Explanation of Significant Difference
From the
Final Record of Decision for the
Naval Reactors Facility - Operable Unit 8-08
Idaho National Engineering and Environmental Laboratory

Naval Reactors Facility – Waste Area Group 8
Operable Unit 8-08, Site NRF-21A, Old Sewage Basin
Idaho National Engineering and Environmental Laboratory
Idaho Falls, Idaho

Figure 2 The Relation of Original Basin to the Expanded Basin

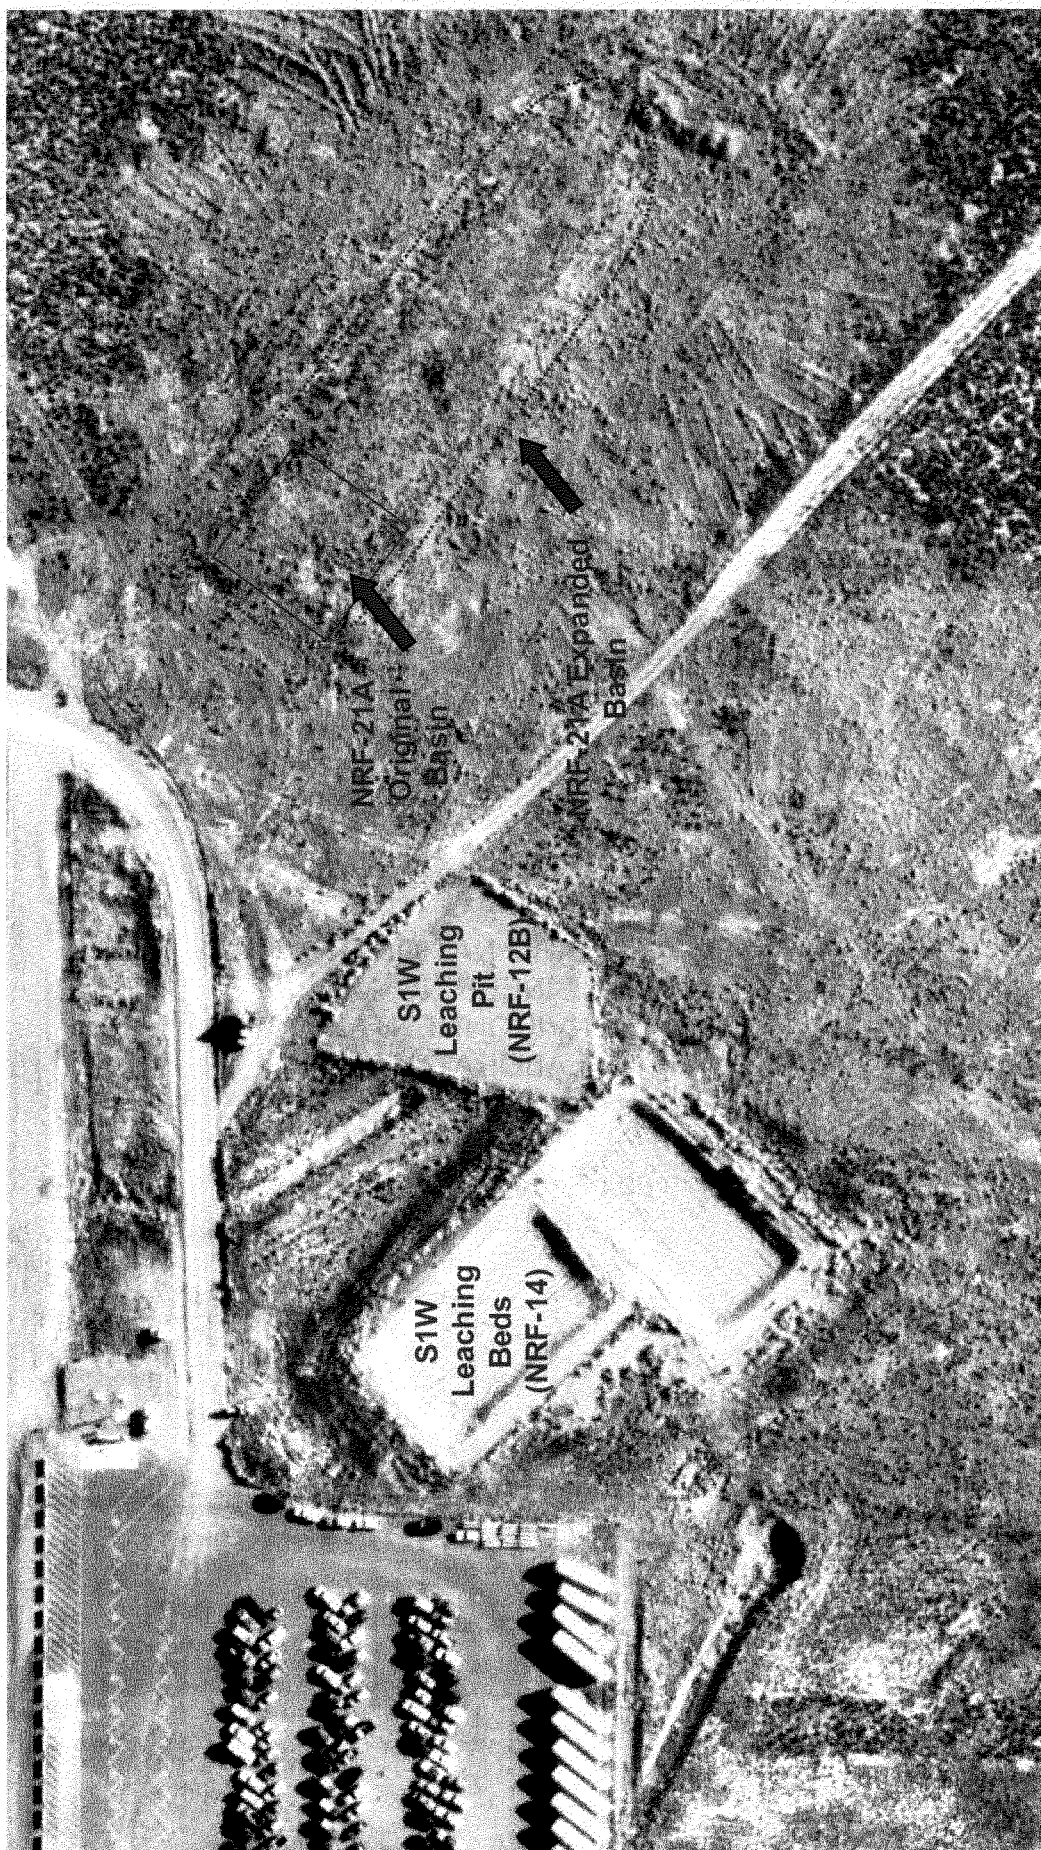
NRF-21A, the Old Sewage Basin, was constructed in 1956 and was enlarged in 1957. It is located outside and southeast of the security fence. Figure 2 shows the relationship between the original basin and the expanded basin. NRF-21A was operated as an open pond until 1960 and was subsequently filled in and abandoned. In 1956, the basin was cross-contaminated from the radiological discharge system. During an investigation of the site in 1991, and again in 1996 during the Remedial Investigation, samples were collected from the basin area. Results from the investigations indicated the presence of nine contaminants of potential concern (COPCs). The list of COPCs included antimony, arsenic, cadmium, chromium, mercury, silver, N-nitrosodi-n-propylamine, cobalt-60, and cesium-137. Only Cesium-137 was detected at concentrations that would pose an unacceptable risk via direct exposure to potential receptors at this site. On the basis of sampling results, the RI/FS concluded that the extent of contamination requiring remediation was limited to a two-foot thick layer located near the discharge pipe at the bottom of the original basin. The RI/FS estimated the volume of contaminated soil for this site at 10,400 cubic feet, based on a 72 X 72 square foot area with a two-foot thickness.

Figure 3 Proposed Engineered Covers for NRF-14, NRF-12B and NRF-21A

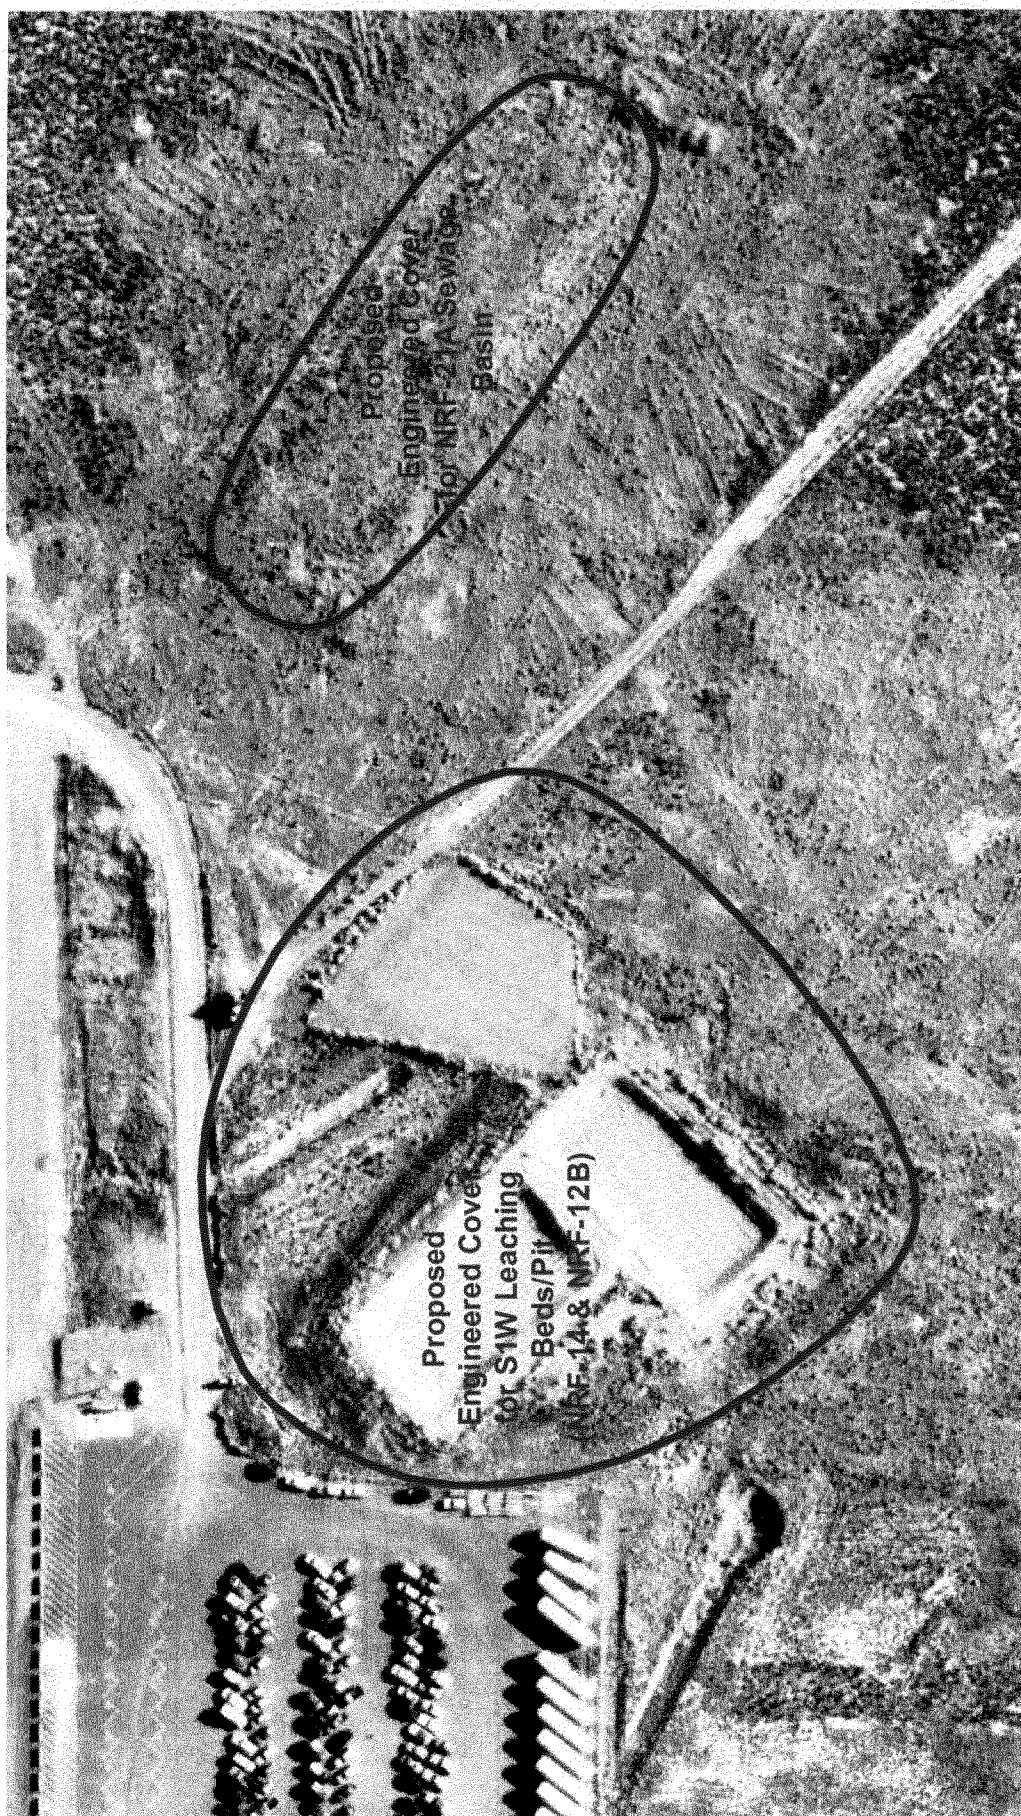
Removal of the NRF-21A buried piping to the basin area, with its associated contaminated soil, will proceed as described in the Final ROD. Instead of removing the contaminated soil at the basin, the present excavation will be secured and filled. The 3 foot mounded area presently over the basin will be removed, and an engineered cover will be designed and constructed over the basin. The area to be covered is approximately 340 feet by 80 feet as shown in Figure 3. An initial assessment shows that a minimal soil cap can cover the majority of the area since contamination is not present until the 8 foot depth in the elongated portion of the basin. Contamination above cleanup levels, as close as 4 feet from the surface, has been detected in the original part of the basin and a slightly thicker cover may be required in this area. It is estimated that a 2 ½ to 3 foot thick cover (above natural grade) over the entire basin will be constructed. The design phase of the cover will consider factors such as subsidence, erosion, runoff, infiltration, and biotic intrusion, and will be documented in the Phase II RD/RA Work Plan. The modified remedial action option (an engineered cover) can be planned and constructed in conjunction with the cover planned at the S1W Leaching Beds (see Figure 3 above). Construction can proceed at both locations simultaneously.
